FINAL PLAT
SMITHMOOR NINTH ADDITION
TO
WICHITA, SEDGWICK COUNTY, KANSAS

S/D 99-20 -- Final Plat of SMITHMOOR NINTH ADDITION

At the regular meeting of the Subdivision Committee of the Metropolitan Area Planning Commission on Thursday, April 22, 1999, the above captioned plat was considered. The action of the Committee was to approve the final plat subject to:

CASE NUMBER: S/D 99-20 - SMITHMOOR NINTH ADDITION

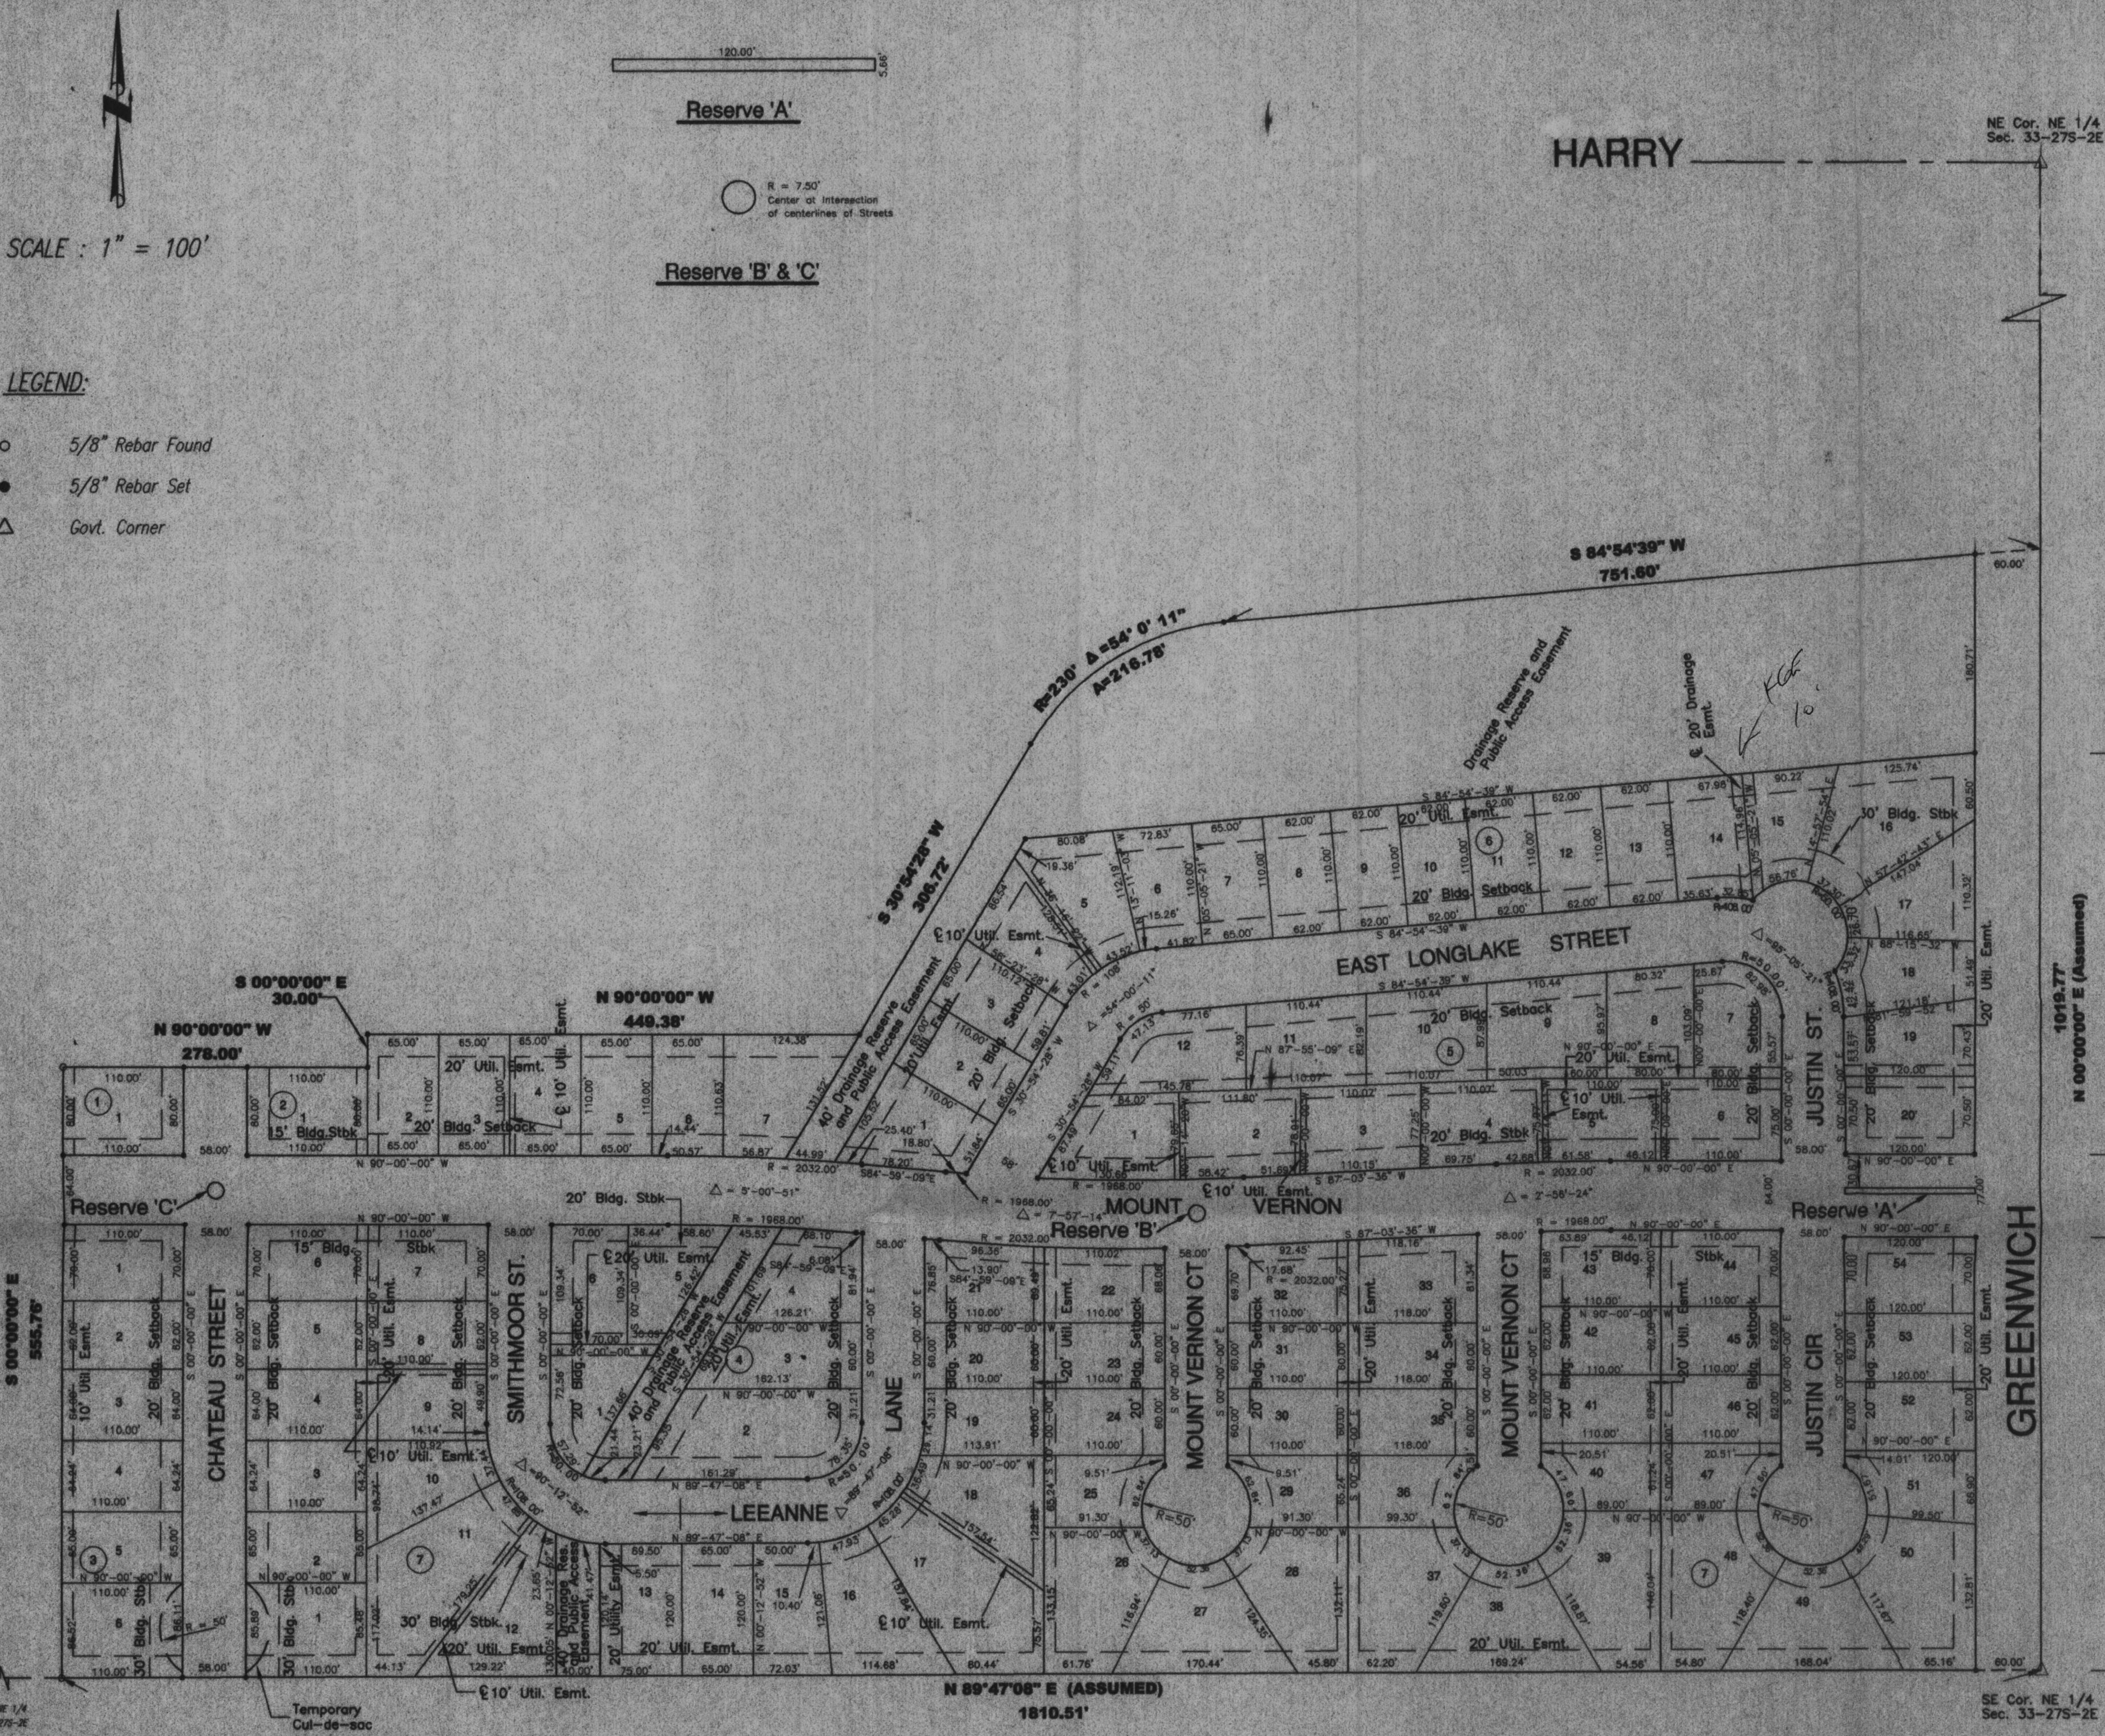
- F. The applicant shall plat a reserve within the 77-ft right-of-way at the entrance to the site. The reserves shall be referenced in the plat's text.

sheet → K. City Fire shall comment on the street names. City Fire has requested new street names on the final plat. Longlake Street shall be designated as "E. Longlake Street". Chateau shall be designated as "Chateau Circle".

L. The legal description needs to be revised to eliminate the paragraph beginning with, "A tract of land located in the west half of the northeast quarter..."

M. The dimension denoted for the east line of the plat does not coincide with the distance identified in the platting binder.

N. On the final plat tracing, the year 1998 shall be replaced with 1999 on all certifications.

O. The MAPC Chair shall be identified as William M. Johnson.

P. The Parks and Pathways Plan has indicated that a recreation corridor should be provided along the south line of this plat. The Applicant should contact the Planning Department's Land Use staff to discuss issues involving the dedication of public access easements. The applicant shall dedicate a public access easement along the drainage reserve.

Q. The platting text shall include language that a drainage plan has been developed for the plat and that all drainage easements, rights-of-way, or reserves shall remain at established grades or as modified with the approval of the applicable City or County Engineer, and unobstructed to allow for the conveyance of stormwater.

The public access easement has been denoted on the final plat.
